TOWN OF BAY HARBOR ISLANDS PLANNING AND ZONING BOARD

April 17, 2018

Subject: Site Development Plan Application – Revision #1
Atlantis of Bay Harbor – 28 DU Multi-Family Residential Complex
10281 West Bay Harbor Drive
Bay Harbor Islands Acct. No. MB2017-21
MMPA Acct. No. 01-0702-1049

Below are all of the changes since the PZ Board approved the plans on March 21st, 2017:

DRAWING TITLE
LEVEL 2 FLOOR PLAN
SCALE: - DATE: APRIL 3, 2018
SHEET NUMBER
A-102
P&Z REVISIONS

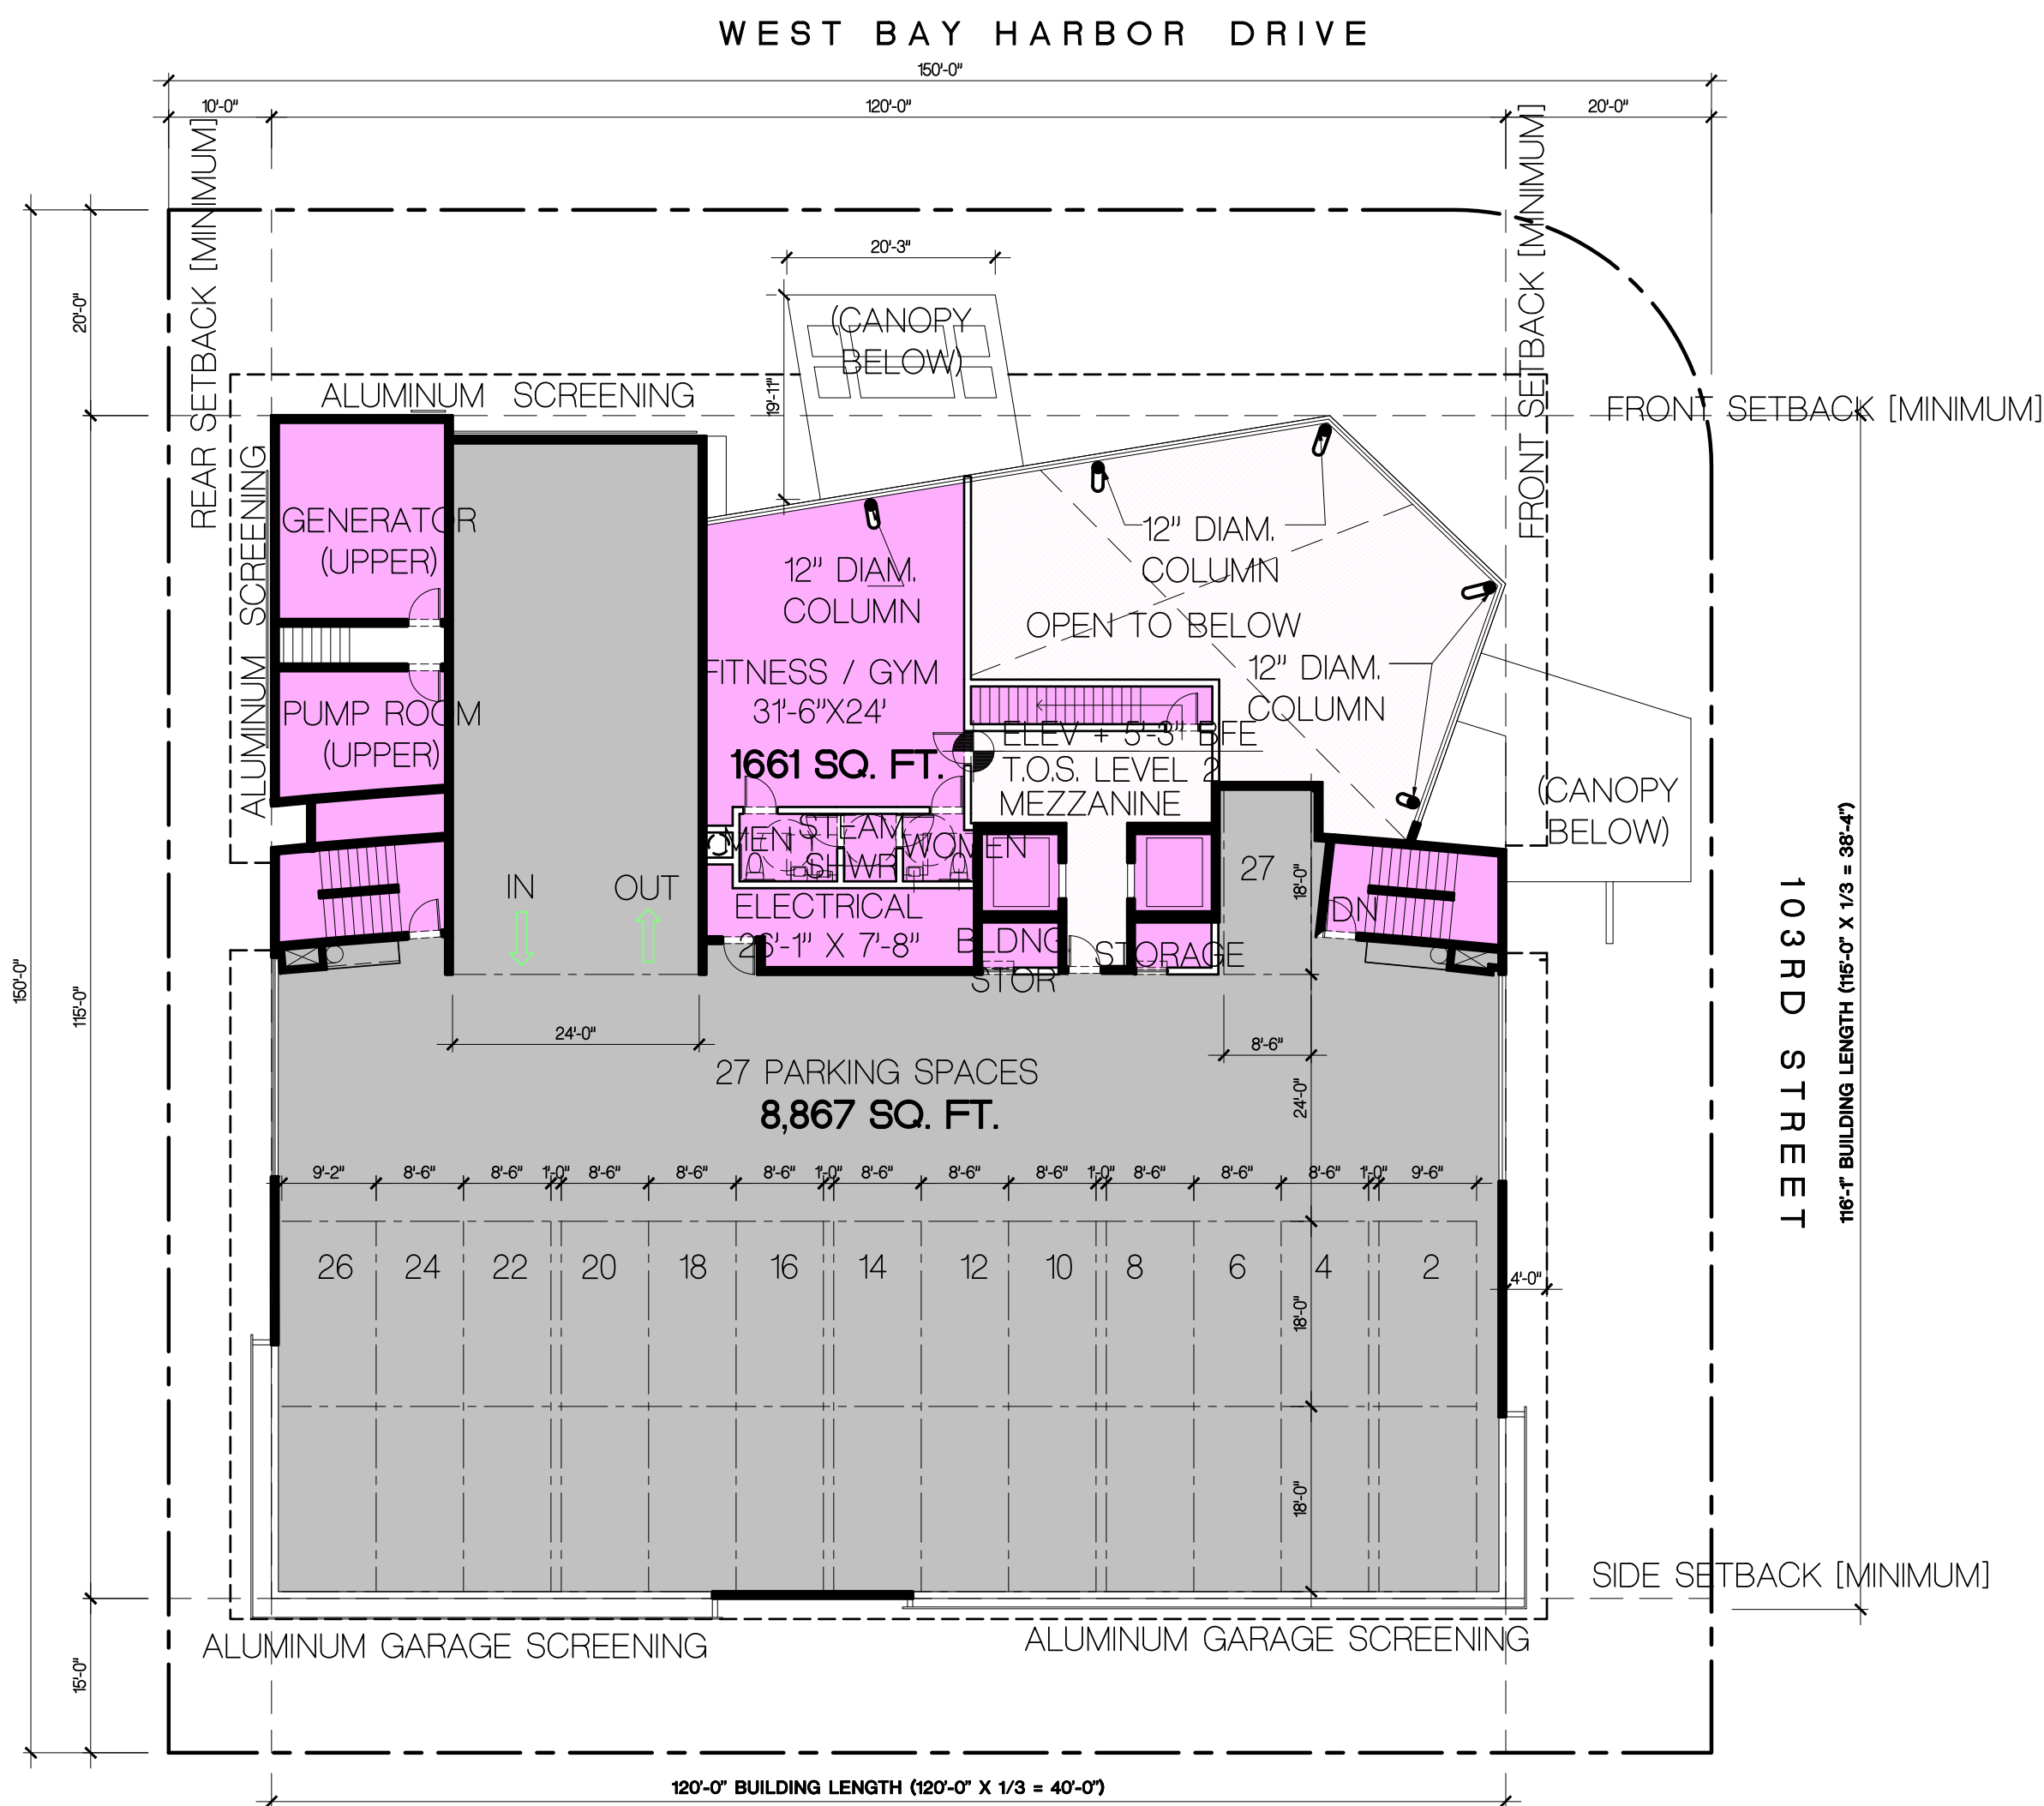
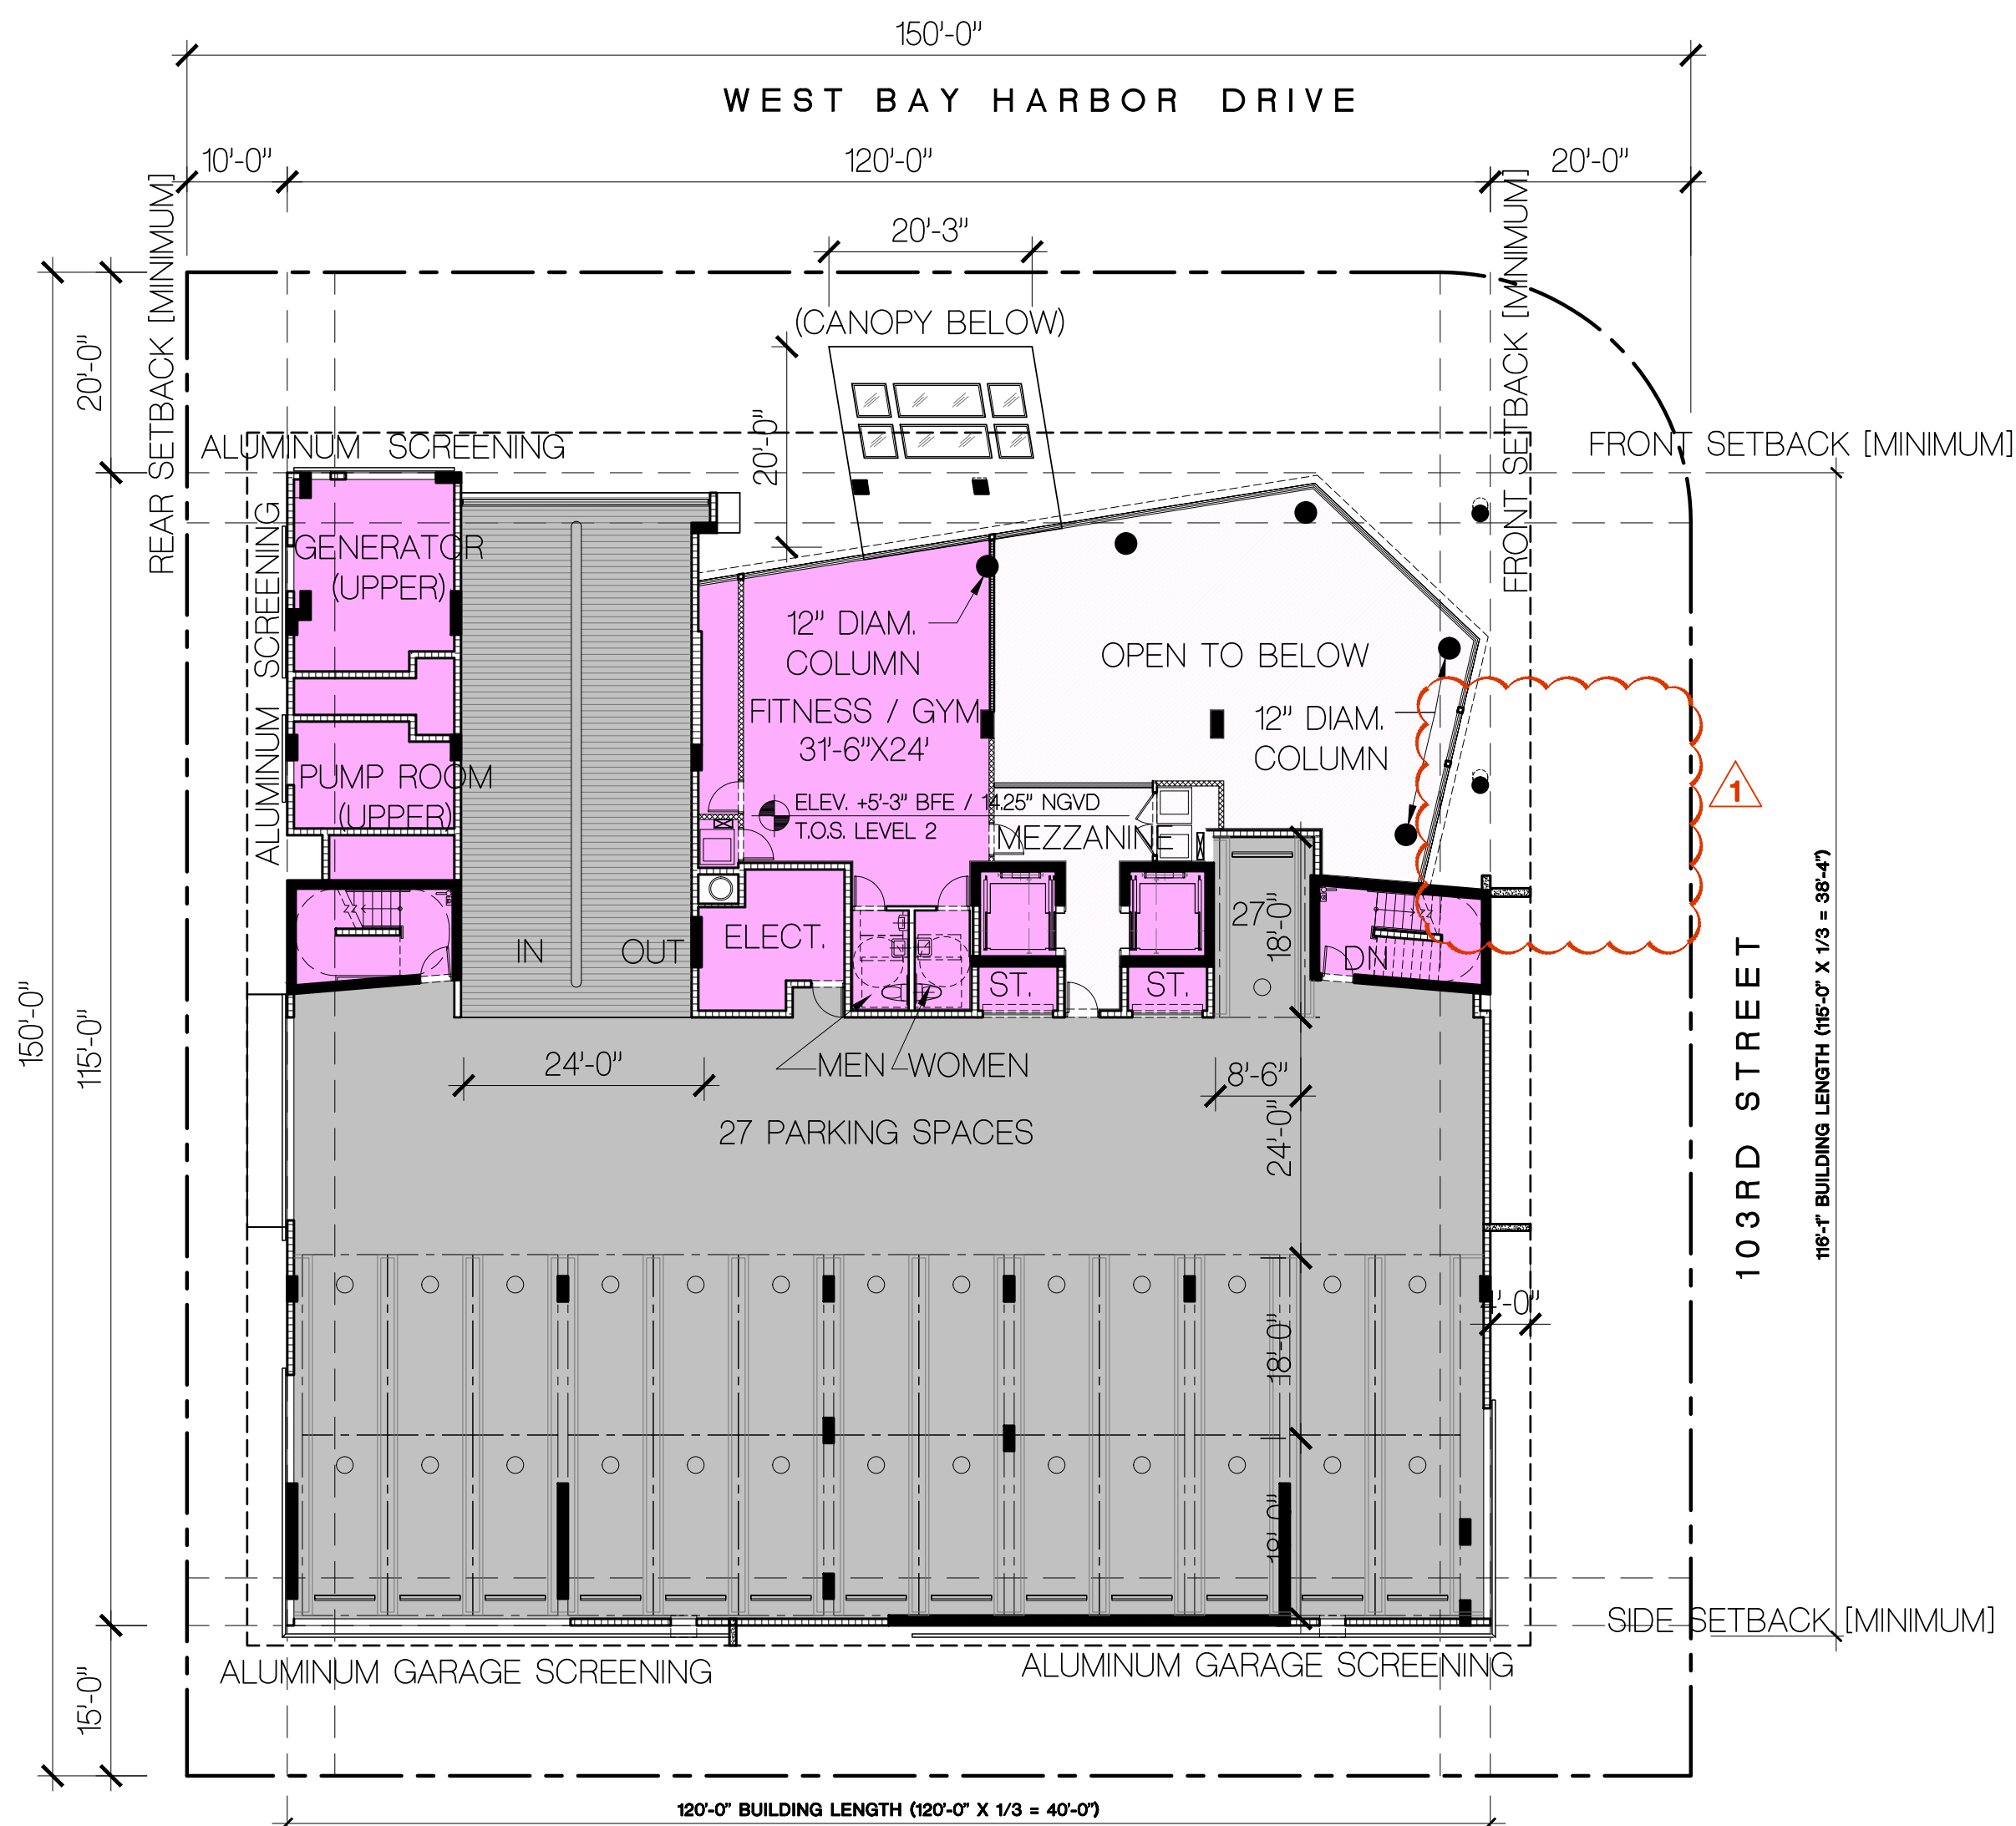
NOTES:
1 REMOVED CANOPY ABOVE WEST WALKWAY.
